Access Compliance Report

Public Rights-of-Way

(Curb Ramps)

Intersection ID: 23951	Main Street: S_TRYON_ST	Cross Street: CHOATE_CR	Location: SE
ADA ID: 461051FA6481	Ramp Type: Perp	Initial Pass/Fail: Fail	Overall Compliance: No
Severity Score: 12.5			
Codes/Mitigation Info/Possible Solution		Field Measurements/Component Compliance

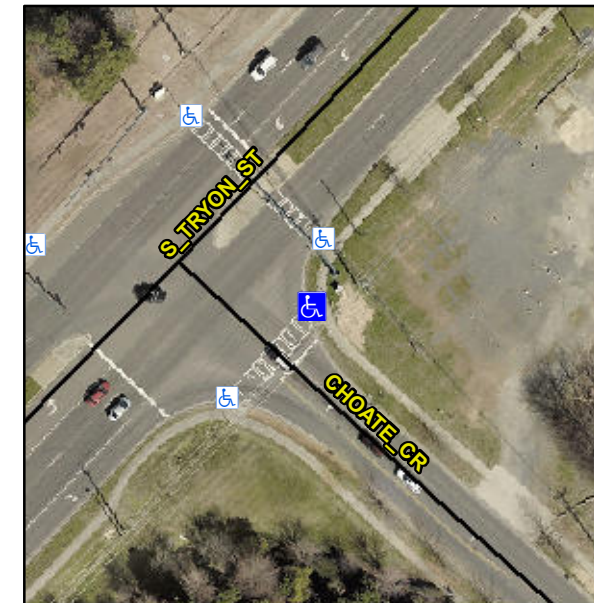
Not Found, R304.2.2

Compliance	Description	Data	Compliance	Description	Data
N/A	Ramp Length (in)	120.0	No	Ramp Slope (%)	9.0
Yes	Ramp Width (in)	48.0	Yes	Ramp XSlope (%)	0.6
N/A	Flare Type LT	N/A	N/A	Flare Type RT	N/A
N/A	Flare Slope LT (%)	N/A	N/A	Flare Slope RT (%)	N/A
N/A	Flare Traversable LT?	N/A	N/A	Flare Traversable RT?	N/A
N/A	Landing Length (in)	N/A	N/A	DWS Provided?	N/A
N/A	Landing Width (in)	N/A	N/A	DWS Contrast?	N/A
N/A	Landing Slope (%)	N/A	N/A	DWS Length (in)	N/A
N/A	Landing X Slope (%)	N/A	N/A	DWS Full Width?	N/A
N/A	Landing Curb? (Y/N)	N/A	N/A	DWS Offset (in)	N/A
N/A	Shared Landing?	N/A			
N/A	Gutter Ponding?	N/A	N/A	Gutter Slope (%)	N/A
N/A	Gutter Lip Ht (in)	N/A	N/A	Gutter X Slope (%)	N/A
N/A	Painted X Walk1?	Yes	N/A	Painted X Walk2?	N/A
	X Walk 1 Direction	To SW		X Walk 2 Direction	N/A
N/A	X Walk 1 Width (in)	114.0	N/A	X Walk 2 Width (in)	N/A
	X Walk 1 Slope (%)	3.0		X Walk 2 Slope (%)	N/A
	X Walk 1 X Slope (%)	3.1		X Walk 2 X Slope (%)	N/A

Remove & Replace Entire Ramp.
